This Drawing Supplies 62 Lots (Subdivision of Proposed Lot 8384)

AMENDMENTS	ORIGINAL ISSUE	DRAFT No. 01	powerlinedesign	POWER LINE DESIGN PTY LTD PO BOX 338 Mittagong NSW 2575 Ph (02) 4872 1920 Fax (02) 4872 1240 Accredited Designer Number 0268 / ABN: 33107 591 846	The preparation of this design has been undertaken giving due consideration to the existing services. The project constructor is wholly responsible for verifying the exact location of existing services and permanent survey marks prior to commencing construction. No responsibility or liability will be accepted by the designer of this project for damage to existing services as a result of this design.	PLD Ref: 3866	Reference Drawings	Work Orders	CAMS File No.	URS25735	ORIGINAL SCALE 1:1000	DO NOT SCALE	Off Richmond Road MARSDEN PARK URS25735 Stage 7F	Endeavour Energy	A1	526363	A	SHEET No 1 OF 4 SHEETS

Off Richmond Road	Off Garganey Pde
MARSDEN PARK	MARSDEN PARK
URS25735	URS25735
Stage 7F	Stage 7F

Electrical Reticulation

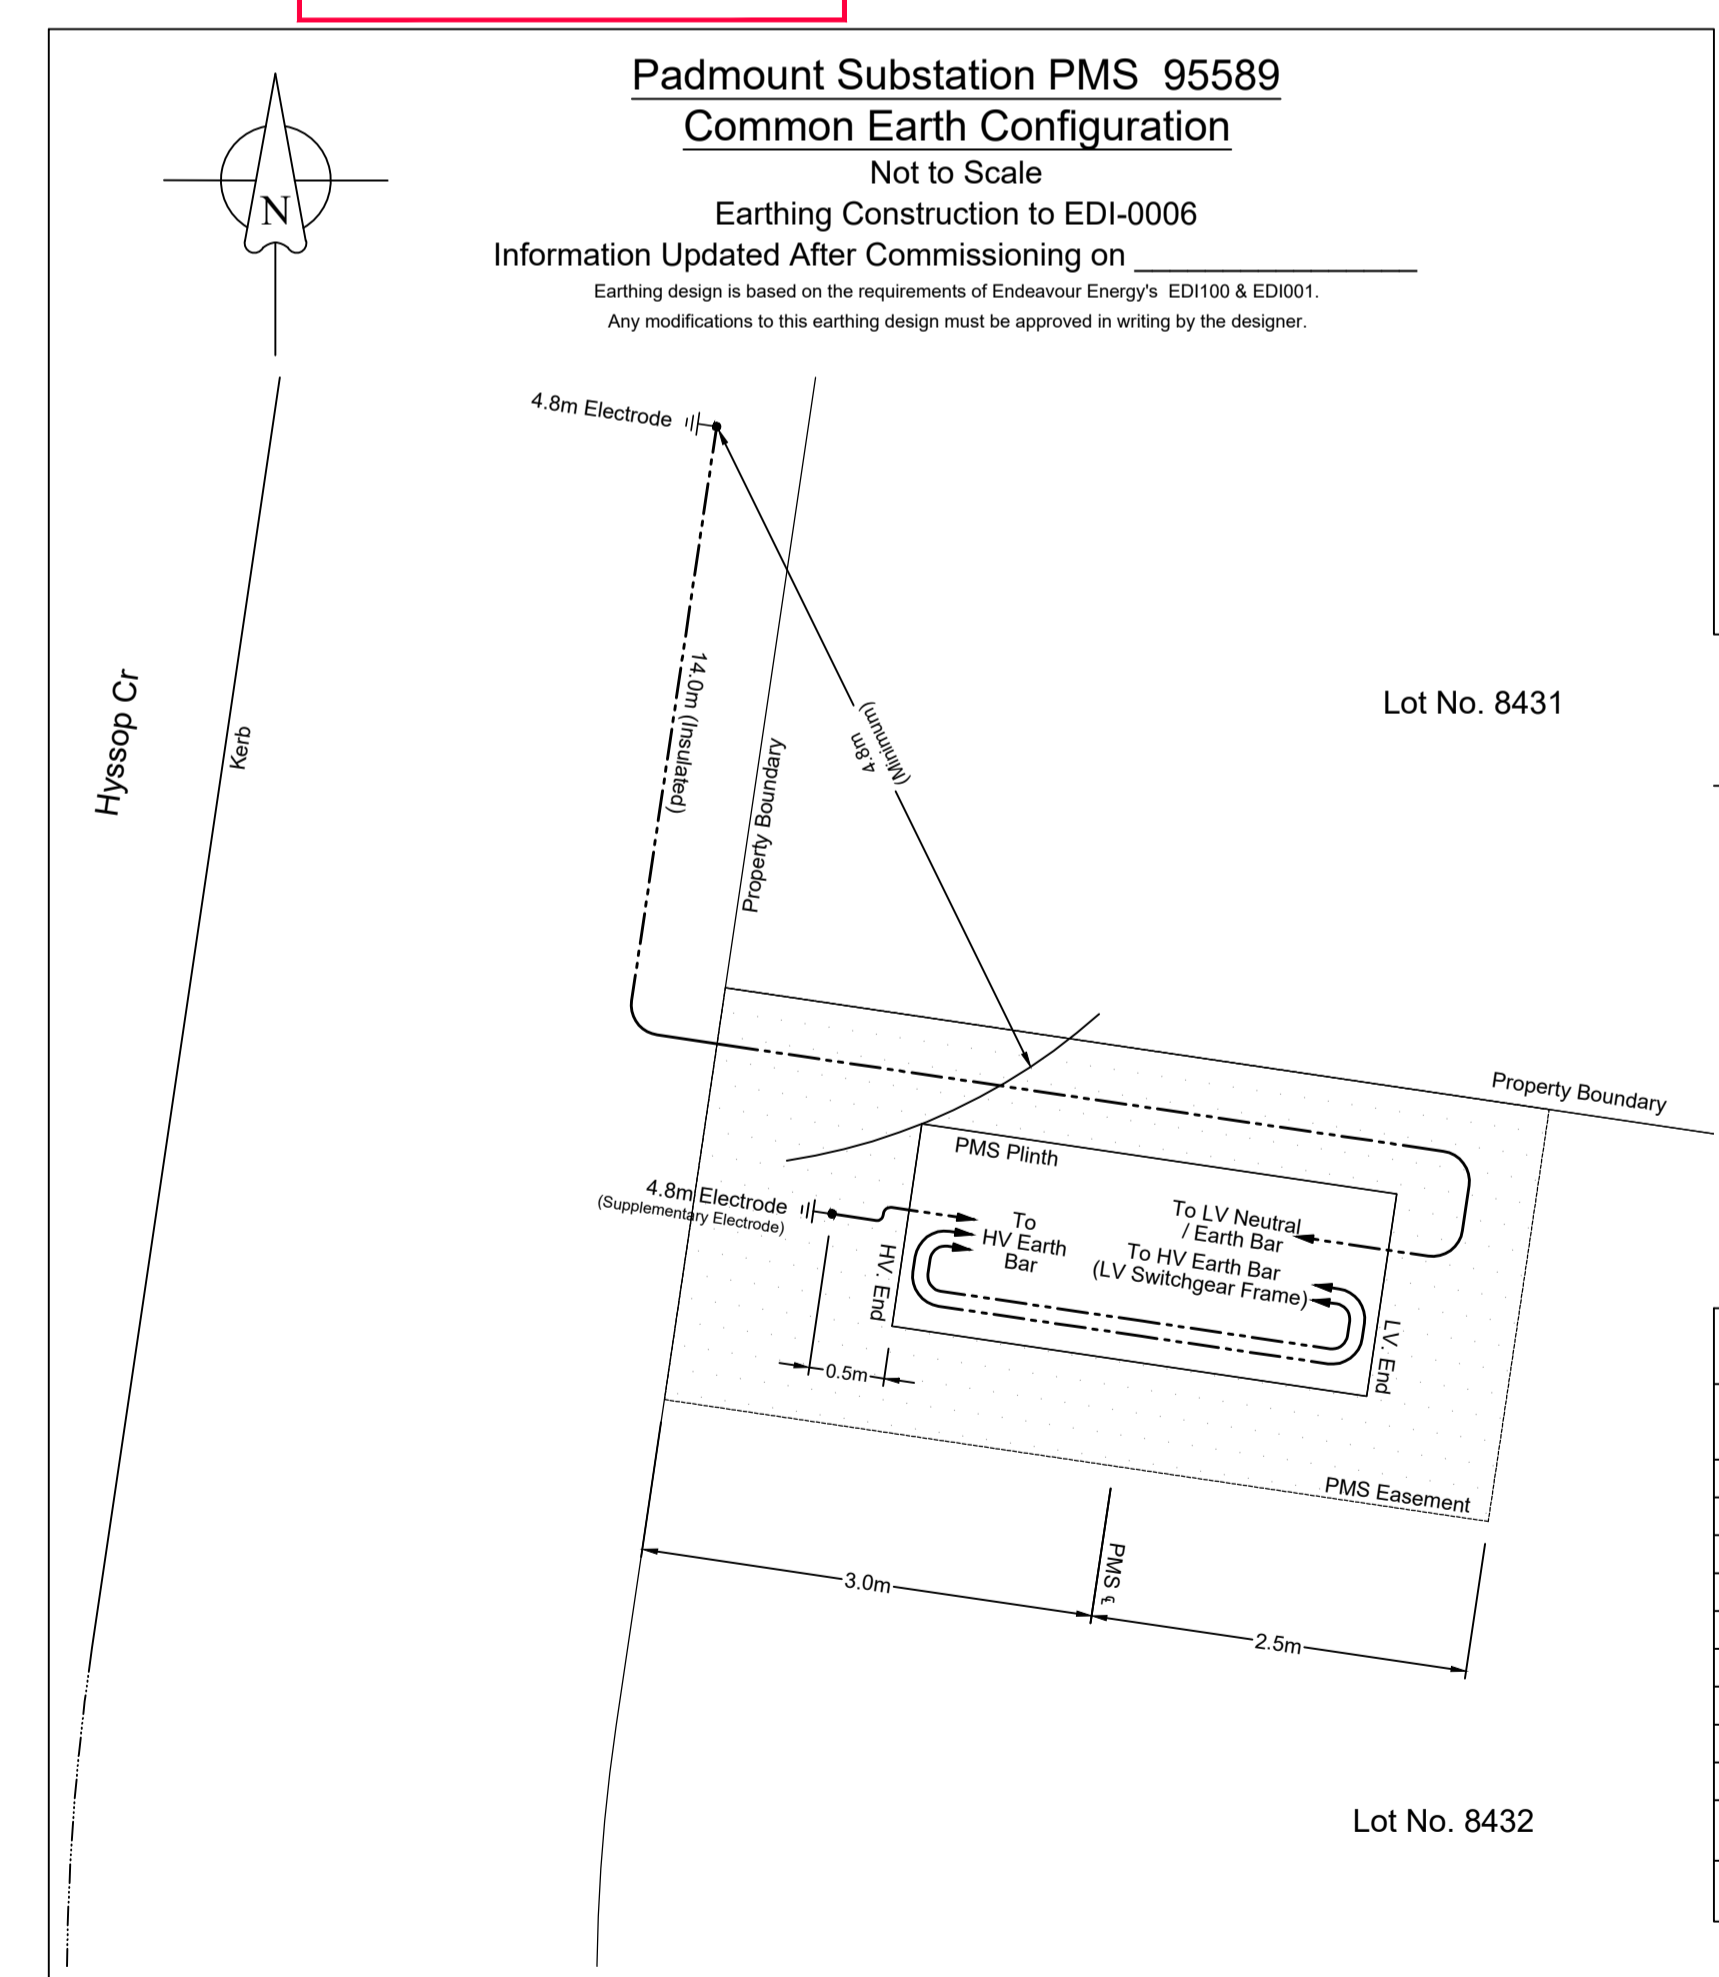
- ONLY CHANGES MARKED UP IN RED FORM ARE PART OF THIS ASSET RECORDING.
- ALL SURFACE ASSETS WERE RECORDED AT LEVEL QUALITY 'C'.
- DUCT TABLE HAS BEEN AMENDED AS PER INSPECTION. REFER TO DUCT SCHEDULE FOR DETAILS.
